ADDENDUM NO. 1

June 18, 2024

DEXTER MUNICIPAL AIRPORT
Rehabilitate Runway 18/36
Project No. 24-076A-1

SCOPE OF WORK

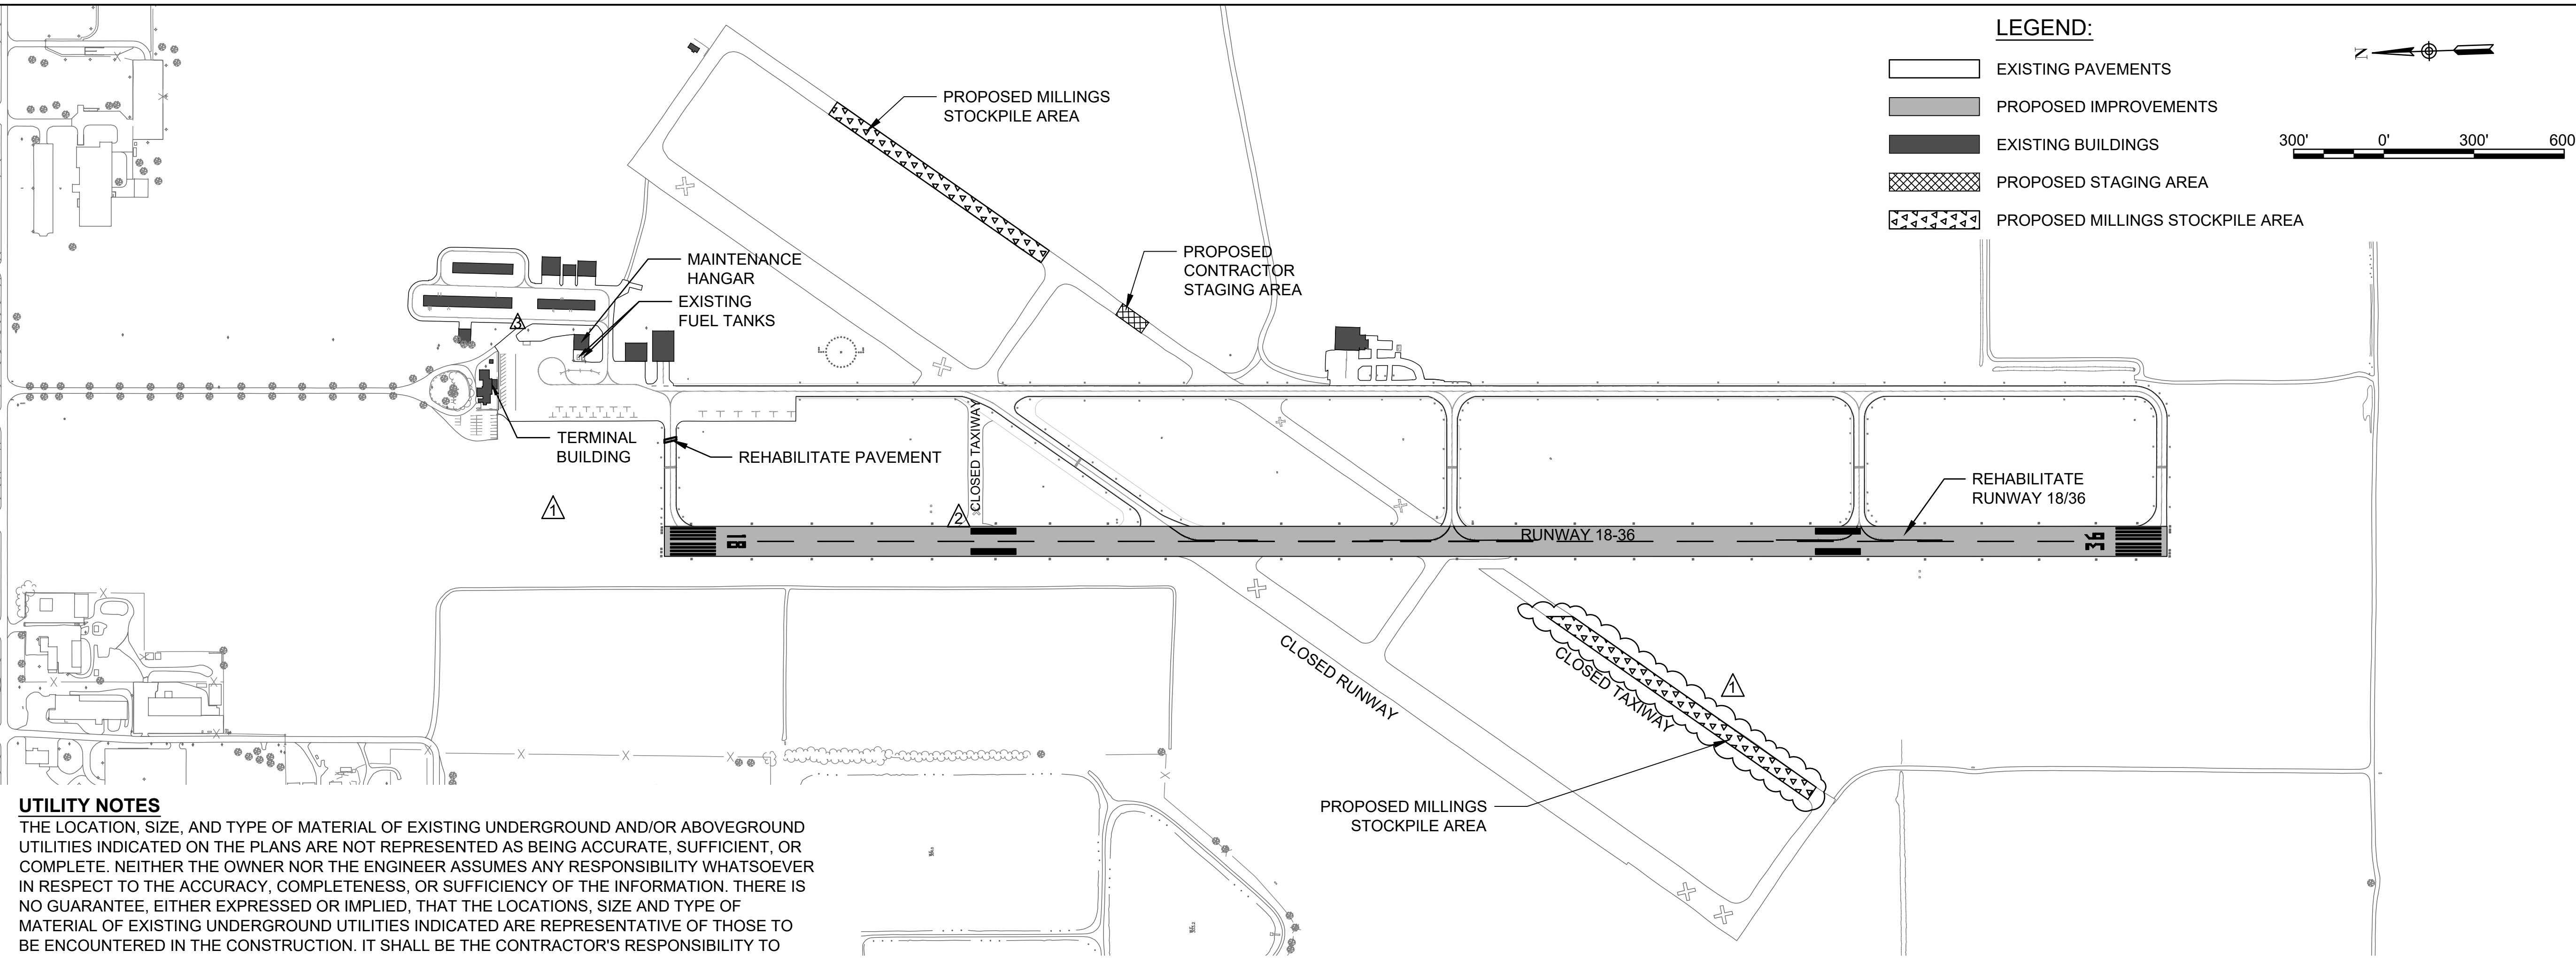
Plan Sheet No. 3, Scope of Work

Delete: Plan Sheet No. 3

Insert: Plan Sheet No. 3 (Revised per Addendum 1), attached

Clarification: The locations of the proposed millings stockpiles have been updated.

CONSTRUCTION SAFETY PLAN

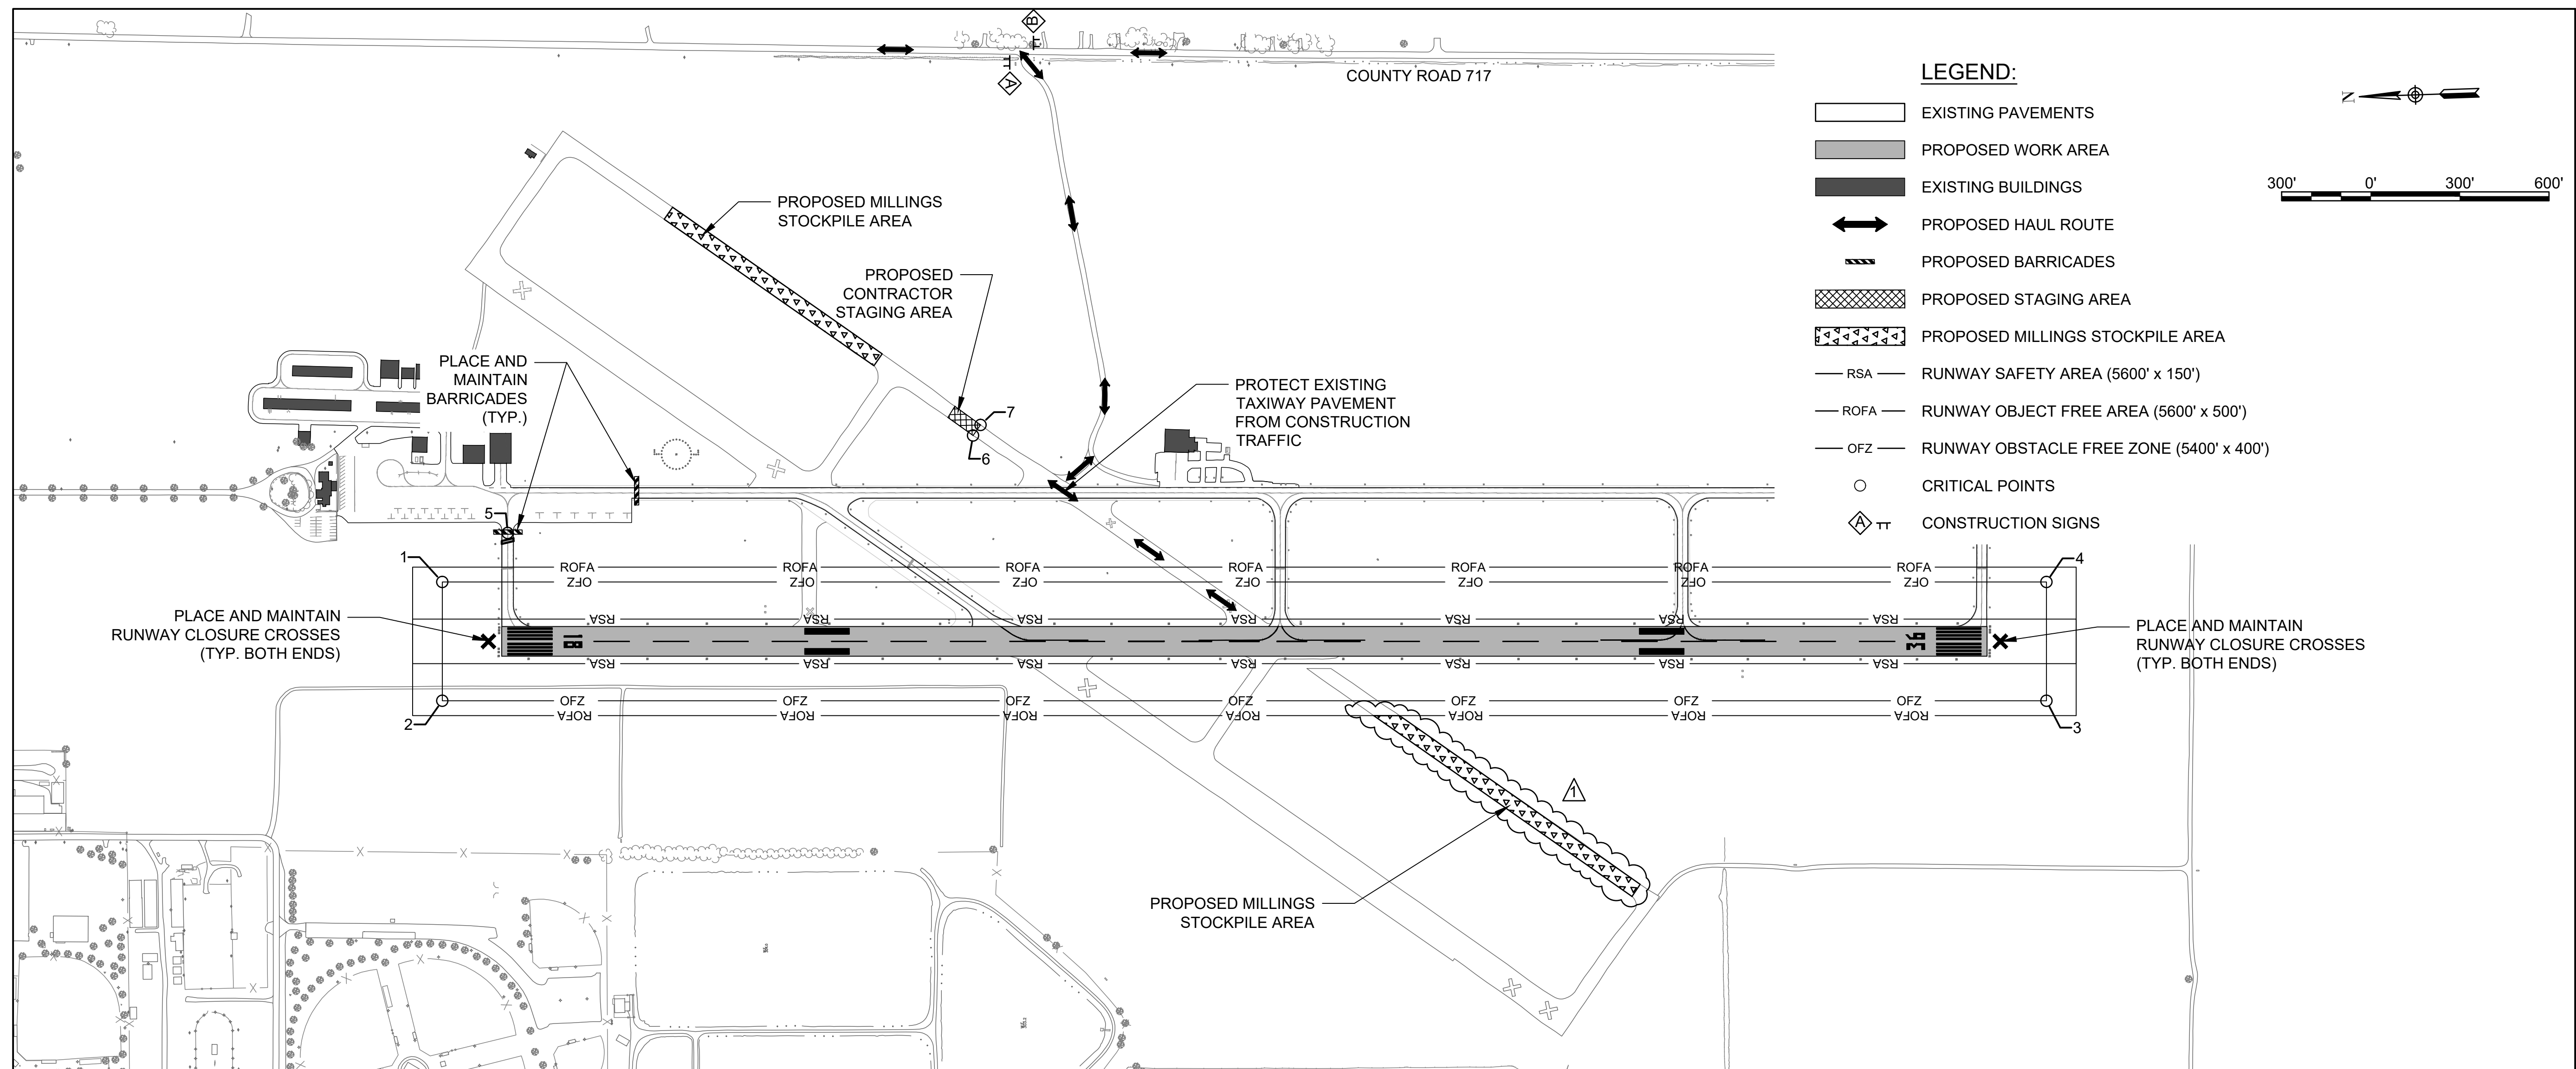
Plan Sheet No. 4, Construction Safety Plan

Delete: Plan Sheet No. 4

Insert: Plan Sheet No. 4 (Revised per Addendum 1), attached

Clarification: The locations of the proposed millings stockpiles have been updated.
